Check report by Sales + CR after finishing stage IV (Apartments)

Quality Control Check Report. Stage: After Finishing Stage III (Apartments)

Quality Control Check Report. Stage: After Finishing Stage II (Apartments)

Details of Additions & Alterations

Description	Direction	Owners & Developers :	Date :	Promoted by
ELECTRICAL PLAN FLAT NOS. 101, 103, 105, 107, 109 & 111	N 	Modi Realty Genome Valley LLP	23.07.2021	Modi Properties Pvt Ltd
		Project Name & Phase :	Prepared By :	
		BRGV	Approved By : Scale :	Soham Modi N.T.S

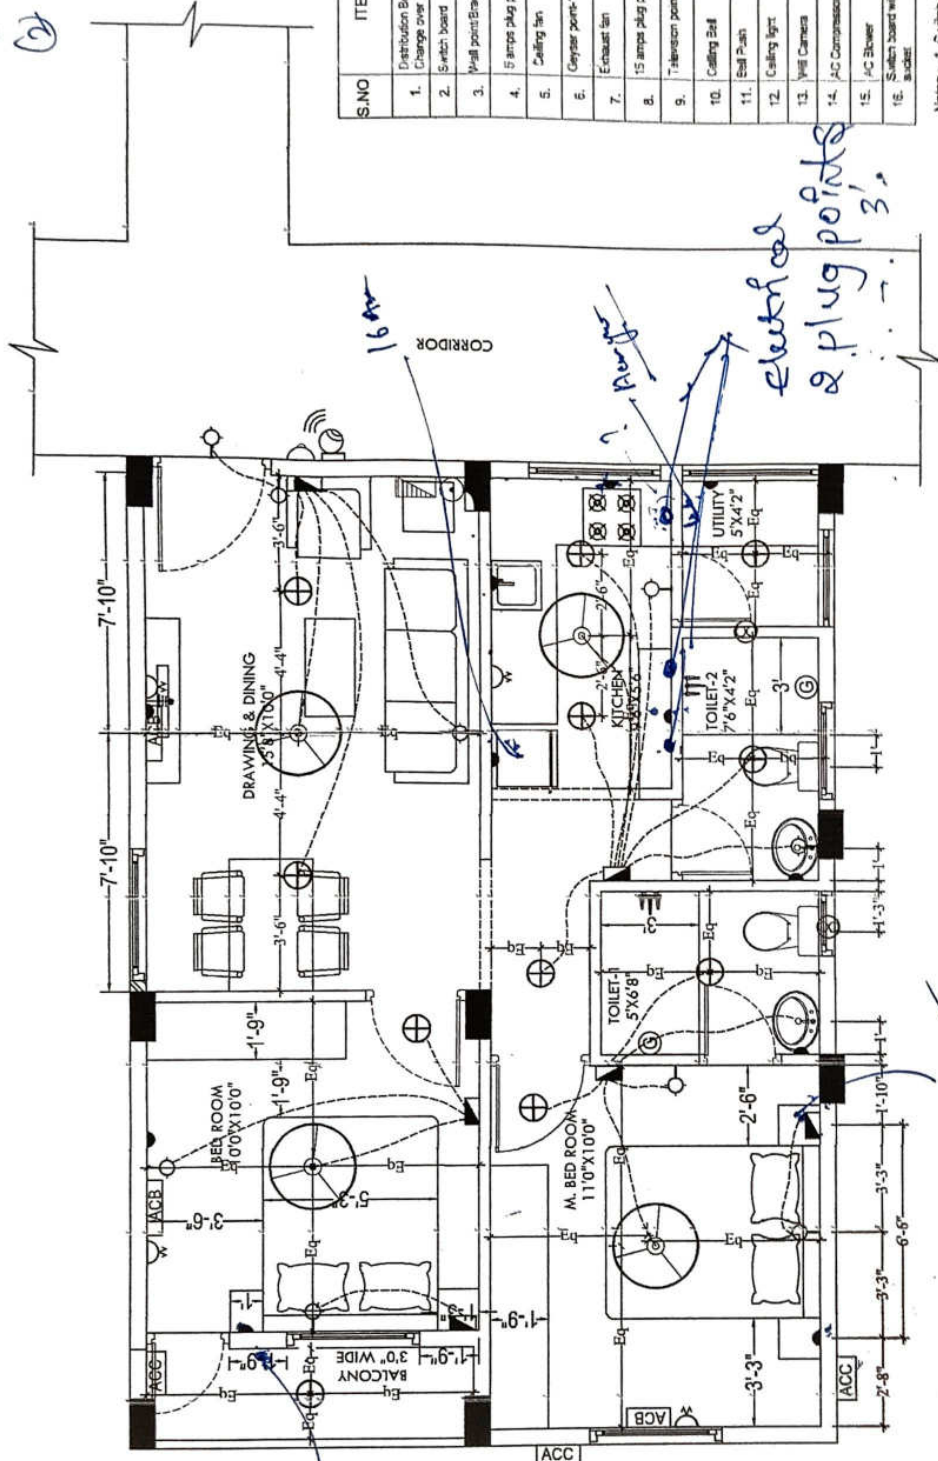
Changes in electrical points: (mark on plan)

- ① In hall, the electrical point should be down.
all fans to be 2A connection.

- (2) Extra ^{extra} foot lamp, 4A should be
- (3) plug point should be taken at entrance of kitchen (Hall).

Changes in kitchen platform: (mark on plan)

- (1) ^{plug point} ~~3~~ extra plug point should be added.
m.c.b wall 3 switch points required.
- (2) in utility area, instead of 1, two plug required.
- (3) ~~also above~~, the kitchen, side wall of utility, plug required.

308

- ① Foot lamp
- ② 2wiring - 2 bed &

electrical
& plug points
3'

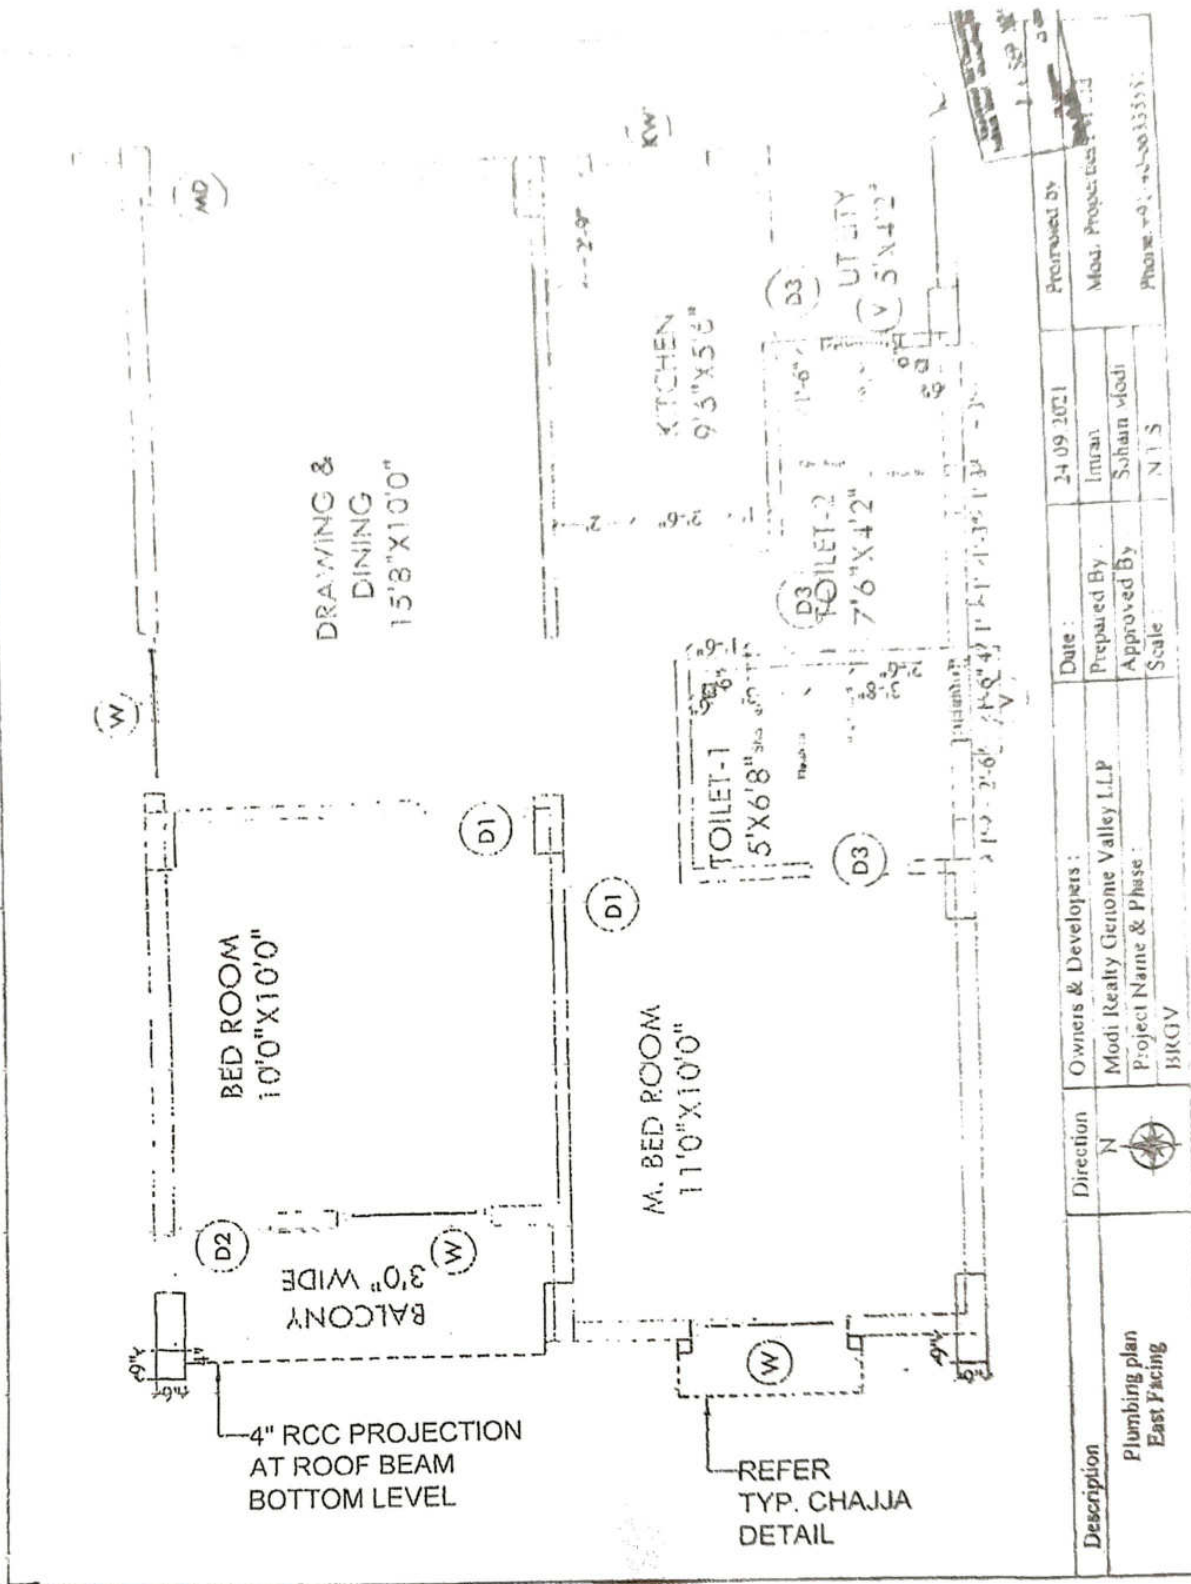
Choice of Bathroom tiles, CP fittings & Sanitary ware:

- (1) ultra sprinkles in both toilets (only in attached bathroom)
- (2) ~~common~~ toilet should be discussed later
